## **Goring on Thames Neighbourhood Plan: Planning Application Assessment**

Assessed by	Name: Date
Planning reference number	P20/S24488/FUL
Summary of application	GNP6 Full Planning Application

**This form assesses the full planning application for GNP6 against the policies of the Neighbourhood Plan. It provides a comprehensive assessment which can be attached to GPC's response to SODC. It will assist SODC to identify the areas of compliance and non-compliance and where additional information is required. It will also provide useful feedback for the applicant on where further evidence or changes are necessary.**

Figure 40 Diagram of detailed sightlines for SSR 5

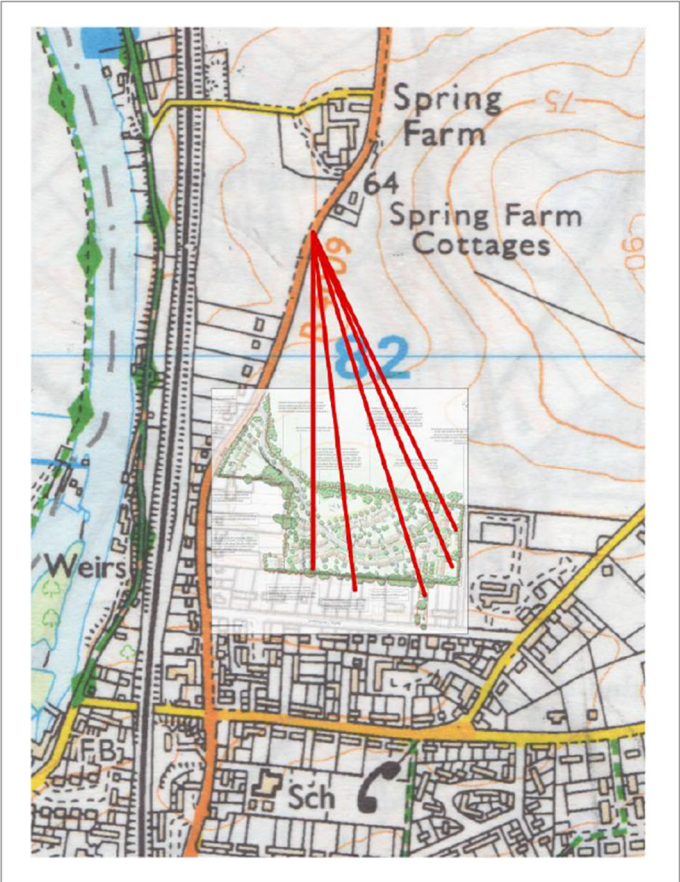
<p>the B4009 between Goring and South Stoke. Only one has been included in the LVIA.</p> <p>The requirement to keep the characteristics of the crest of the hill is defined below in Policy.08 SSR5 (GNP p59) as <i>“Rooftops <b>and screening for houses</b> on the site should not be visible above the ridge line in views from Wallingford Rd, particularly from between Spring Farm Barns/Cottages and 91 Wallingford Rd but also from the road to the north of the Spring Farm hamlet. Detailed cross-sections should be taken along a series of sightlines including those shown on plan below to make sure that this condition is met.”</i></p> <p>All of this is summarised inaccurately in the planning application Planning Statement 7.9 p19 as: <i>‘Rooftops should not be visible above the ridgeline; the application should include cross sections.’</i> From this stem the presumption throughout the application that tree planting to screen rooftops is acceptable on the skyline. It is not. <b>The line of uncharacteristic new vegetation and trees on the ridgeline proposed in the planning application is in breach of GNP Policy.08 SSR5.</b></p> <p>The Planning Application states that rooftops will not be visible above the ridge line but fails to provide the detailed cross-sections from a series of sightlines as defined in this Policy.08 and confirmed as a requirement in the SODC Full Pre-Application Response.</p> <p>The comments of the Urban Design Officer in the SODC Pre-application Report regarding gardens facing the open countryside are very apposite to the proposed design. An outward-facing design for the front of relevant properties would enable provision of a more enclosed rear garden space than in this layout.</p> <p>Evidence must be provided which clearly demonstrates that all properties, but in particular properties 6, 7, 17, 18 and 19 in the proposed design, are not visible from multiple viewpoints as defined in Policy.08 SSR 5.</p> <p>There are several other factors below which further support why a redesign of aspects of the site and a reduction in the number of houses is required before this planning application can be accepted.</p> <p>Removal of dwellings that are proposed towards the higher parts of the site, (above the 65m AOD) and redesign of the site with less houses would facilitate conformance with the requirements specified in the NP.</p>

<p>5. Rooftops and screening for houses on the site should not be visible above the ridge line in views from Wallingford Road, particularly from between Spring Farm Barns/Cottages and 91 Wallingford Road but also from the road to the north of the Spring Farm hamlet.</p> <p>Detailed cross-sections should be taken along a series of sightlines including but not limited to those shown on the plan below to ensure that this condition is met.</p> <p>See end of document</p>	<p style="text-align: center;"><b>N</b></p>	<p>Only one cross section showing the crest of the hill has been provided in the Design and Access Statement 3.8. The profile shows how close the roof lines of the highest buildings are to the crest and how vulnerable this sight line is to any future changes eg TV aerials, satellite dishes, fences, trees etc</p> <p>The SSR requires a series of cross-sections from different positions to be provided (see left). This requirement was reiterated by SODC in the Pre-app report.</p>
